Rezoning Application: RZ-PD 25-0932

Development Services Department

1.0 APPLICATION SUMMARY

FIGURE 2: PROPOSED TYPICAL SECTION

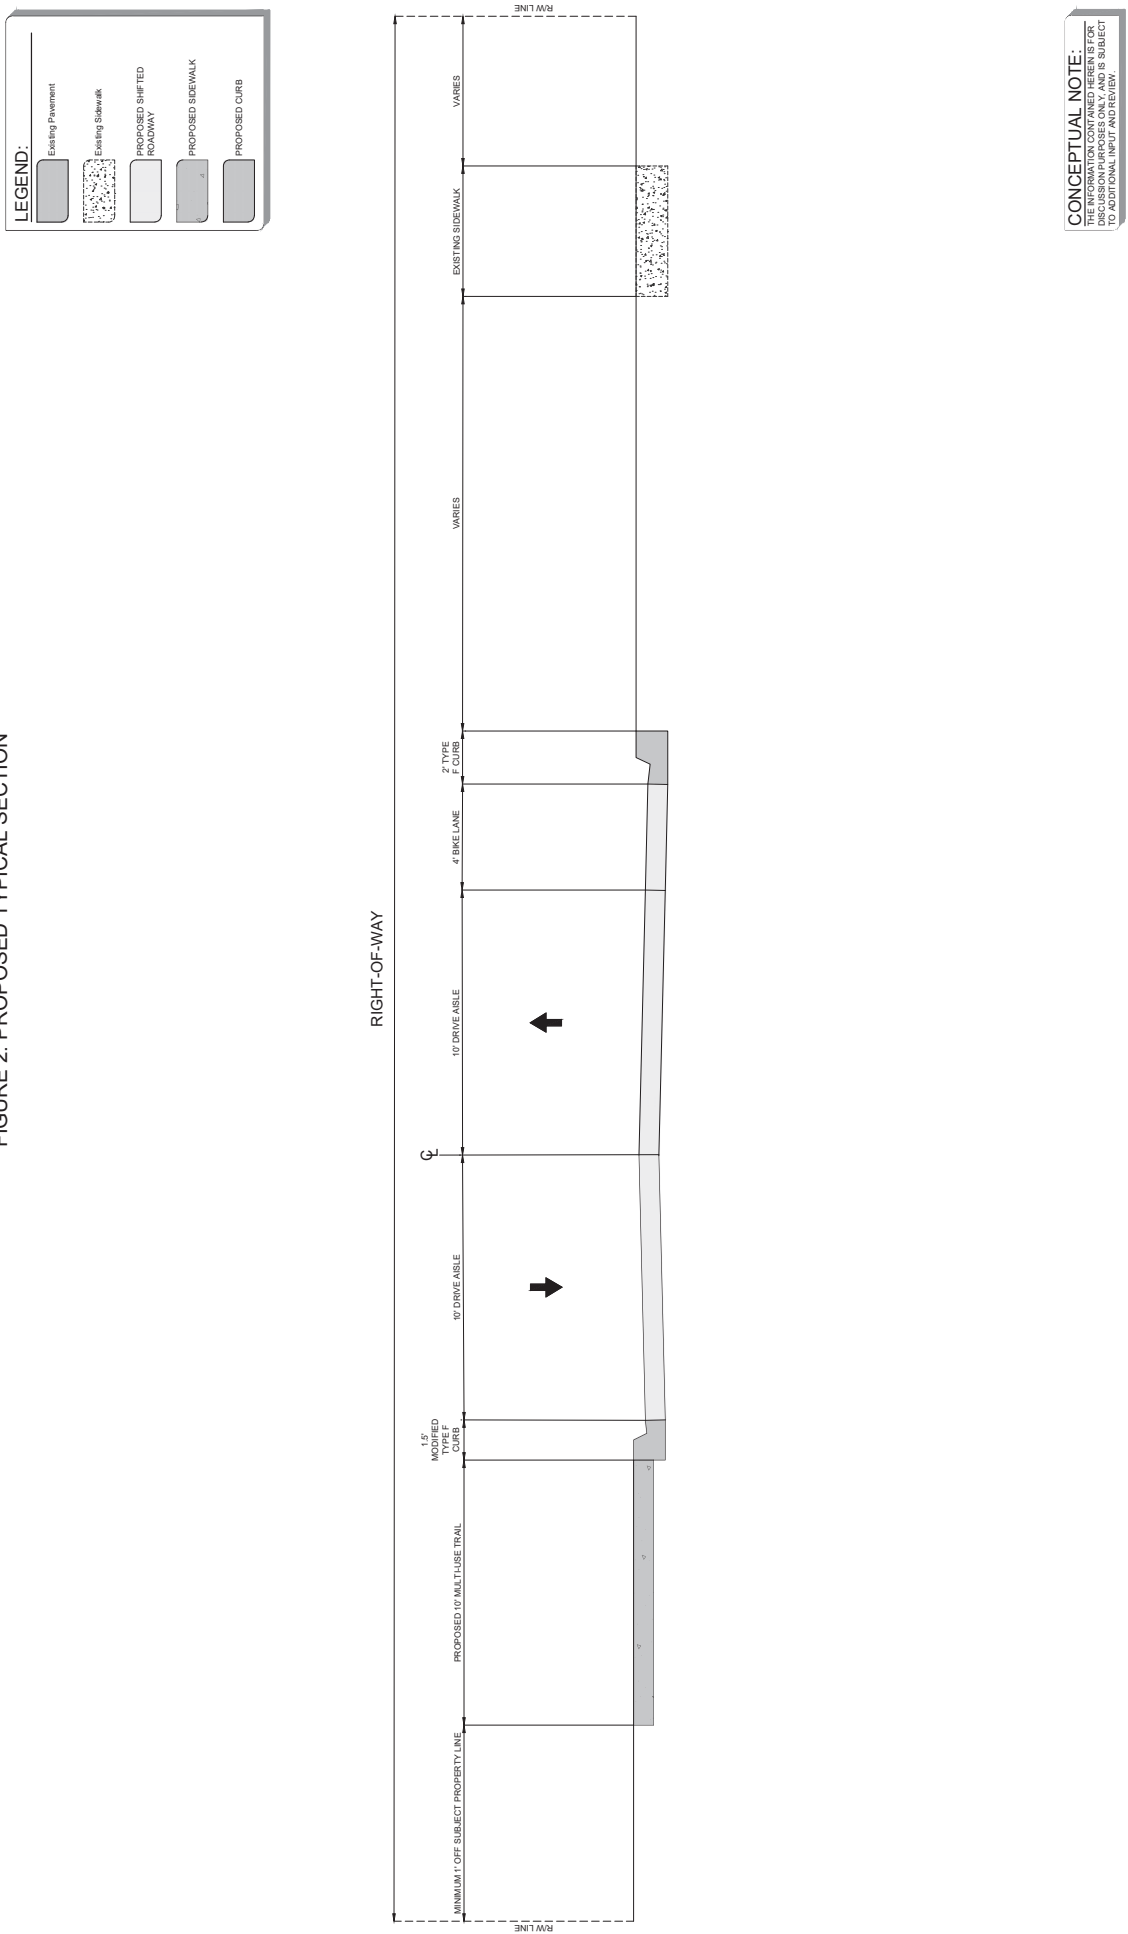
3. On the east side of Fern Hill Drive, the request is to maintain and complete the missing sections of the 4-foot bike lane instead of the 7-foot buffered bike lanes. This will add approximately 350 feet on the east side of Fern Hill Drive.

4. On the west side of Fern Hill Drive, the request is to construct a 10-foot multi-use path instead of the 7-foot buffered bike and 5-foot sidewalk. This will add approximately 850 feet of 10-foot multi-use path (550 feet along project frontage and 300 feet off site)

5. The request is to maintain and complete the missing sections of the F type curb. This will add approximately 850 feet of modified F type curb on the west side and approximately 350 feet of F type curb on the east side of Fern Hill Drive.

6. The request is to maintain and complete the missing sections of the grass strip at the back of sidewalk. Along the east side of Fern Hill Drive, the grass width varies between 5 and 20 feet. No modification along the east side is proposed. Along the west side, a minimum 1-foot strip will be provided from the project boundary (just north of Field Blend Court) south approximately 850 feet.

7. The request is to maintain the 5-foot sidewalk along the east side of Fern Hill Drive, therefore no modification is proposed.

11. If PD 25-932 is approved, the County Engineer will approve a Design Exception (dated July 29, 2025 and last revised October 13, 2025) which was found approvable by the County Engineer (on October 14, 2025) for the Fern Hill Dr. substandard roadway improvements. As Fern Hill Dr. is a substandard collector roadway, the developer will be required to construct the following

PD SITE PLAN
OPTION 2

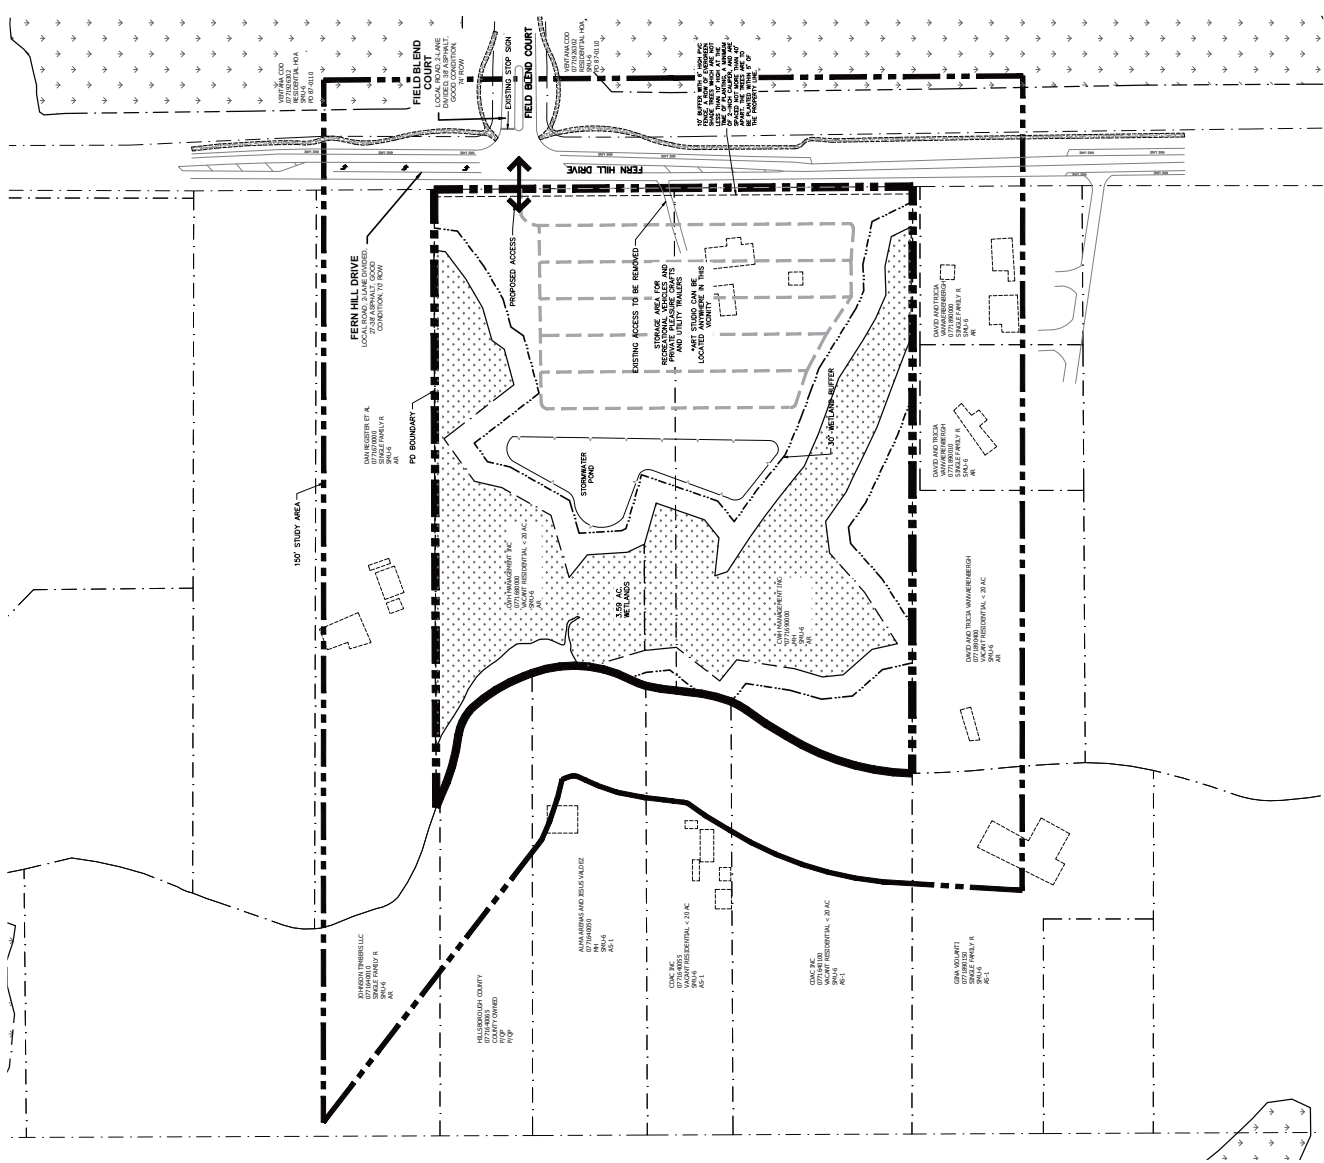
- On PD Site Plan Sheet 2 of 2:
 - Within the “Proposed Use” column of the “Uses Table”, revise the language stating “OPTION 2: RECREATIONAL VEHICLES AND PRIVATE PLEASURE CRAFTS AND UTILITY TRAILERS STORAGE & ART STUDIO (CN USE)” to instead state “OPTION 2: RECREATIONAL VEHICLES AND PRIVATE PLEASURE CRAFTS AND UTILITY TRAILERS STORAGE & ART STUDIO”.
